# APPROVED MINUTES

## February 15, 2024, Standards Committee Meeting

RE: Minutes from the February 15, 2024, Standards Committee Meeting

**C. STANDARD SPECIFICATIONS, SPECIAL PROVISIONS, AND STANDARD DRAWINGS PROPOSAL**

INDIANA DEPARTMENT OF TRANSPORTATION	
PEDESTRIAN DETOUR CORNER CLOSURE	
SEPTEMBER 2024	
STANDARD DRAWING NO.	E 801-TPAR-02
DESIGN STANDARDS ENGINEER	DATE
CHIEF ENGINEER	DATE

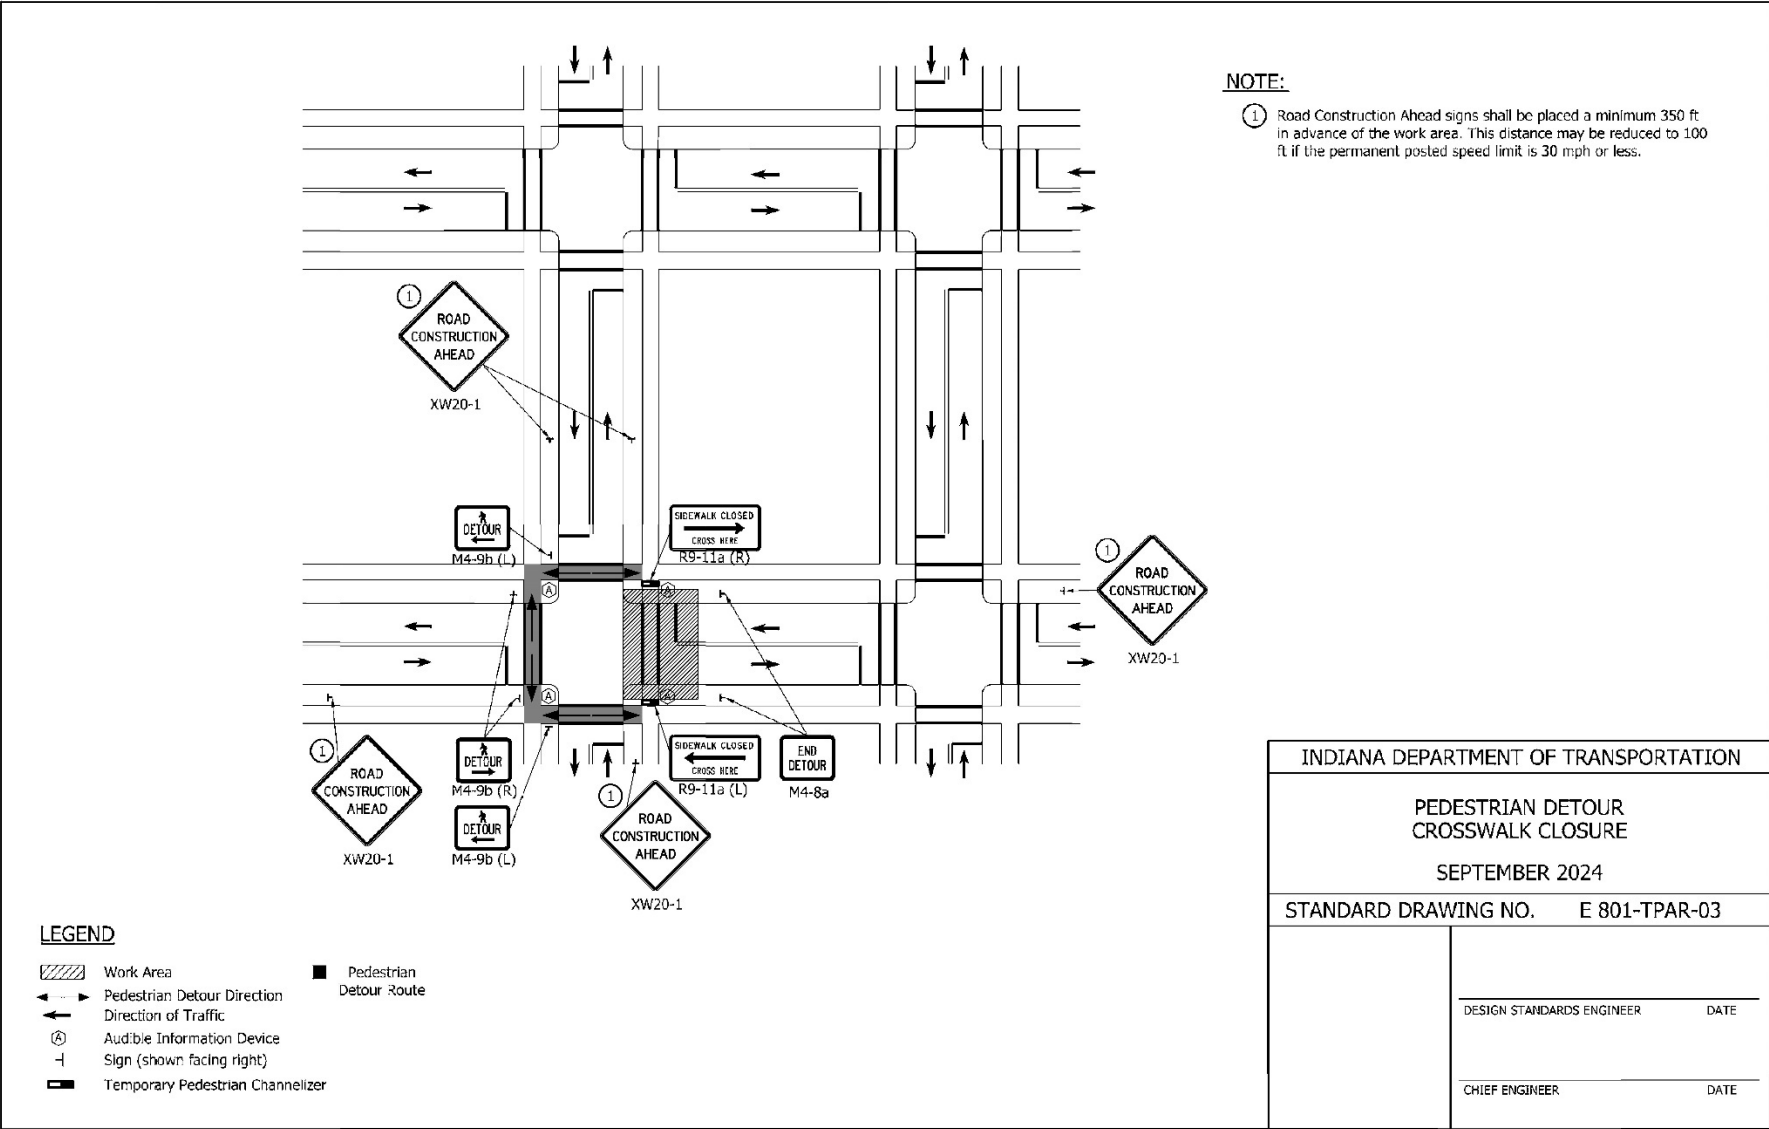
Mr. Laracuente suggested adding a note to the drawings that access to businesses and residences shall be maintained. Mr. Koch added that there is language in 107.08(e). Mr. Boruff asked Ms. Smutzer if language can be added to 107.08 for access. A small change will be made to the drawing E-801-TPAR-02 regarding the audible information devices that need to be shown, so Mr. Boruff revised his motion. Mr. Orton seconded the revised motion.

Note: Revised draft of the E 801-TRAP-02 is shown in these minutes.

<b>INDIANA DEPARTMENT OF TRANSPORTATION</b>	
<b>TEMPORARY CURB RAMPS</b>	
<b>SEPTEMBER 2024</b>	
<b>STANDARD DRAWING NO.</b>	<b>E 801-TPAR-10</b>
DESIGN STANDARDS ENGINEER	DATE
CHIEF ENGINEER	DATE

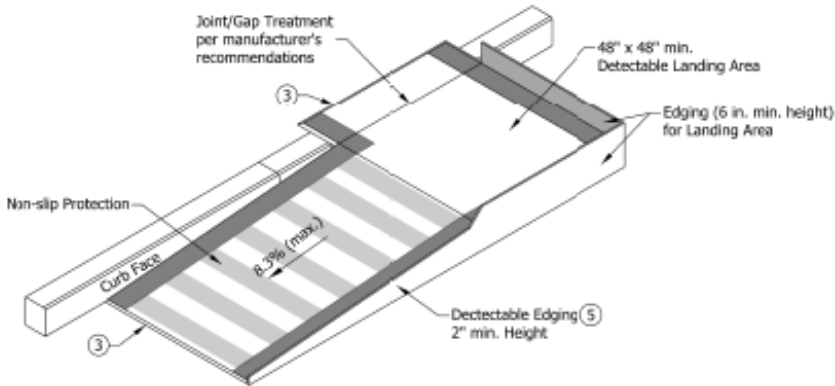
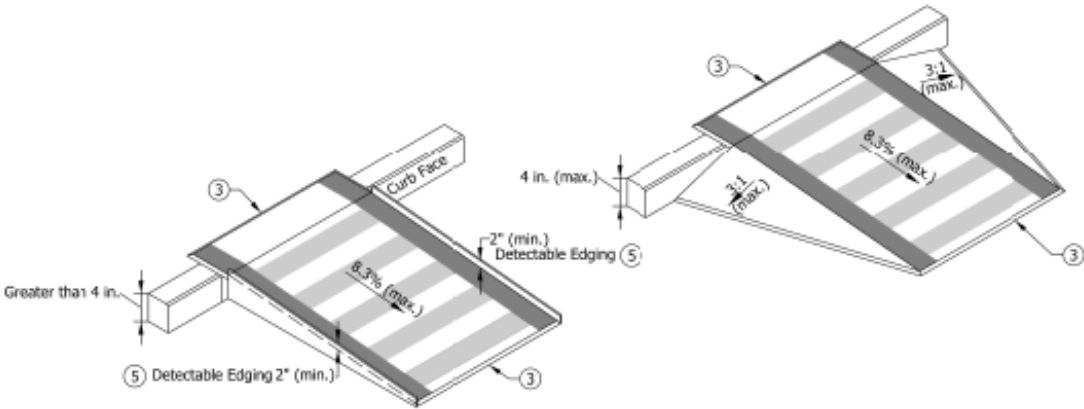
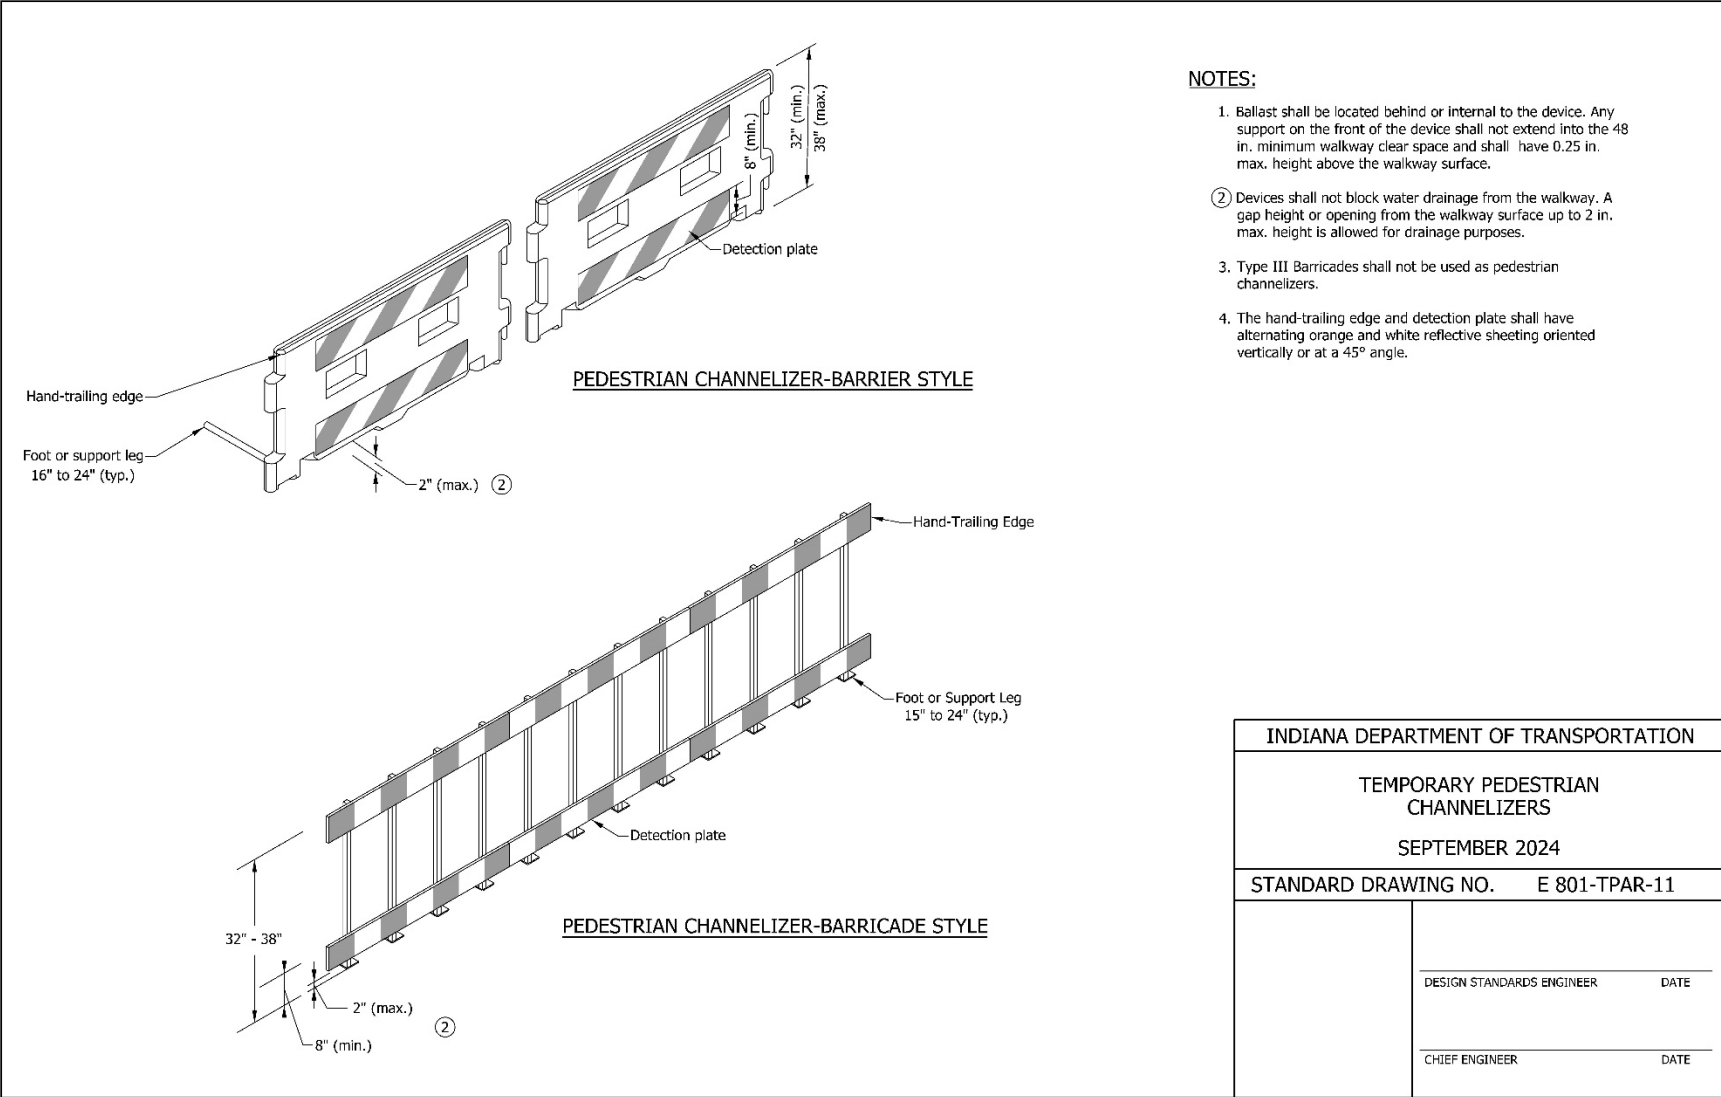
6. The rise of a single temporary curb ramp shall be no more than 30 in. If more than one temporary curb ramp is needed at a location due to the change in elevation, a minimum 5 ft landing area shall be used between curb ramps. The landing area shall have a slope of less than 2.0%.

7. The table below is for common curb heights, the curb ramp length for other curb heights shall be based on having a maximum slope of 12:1.
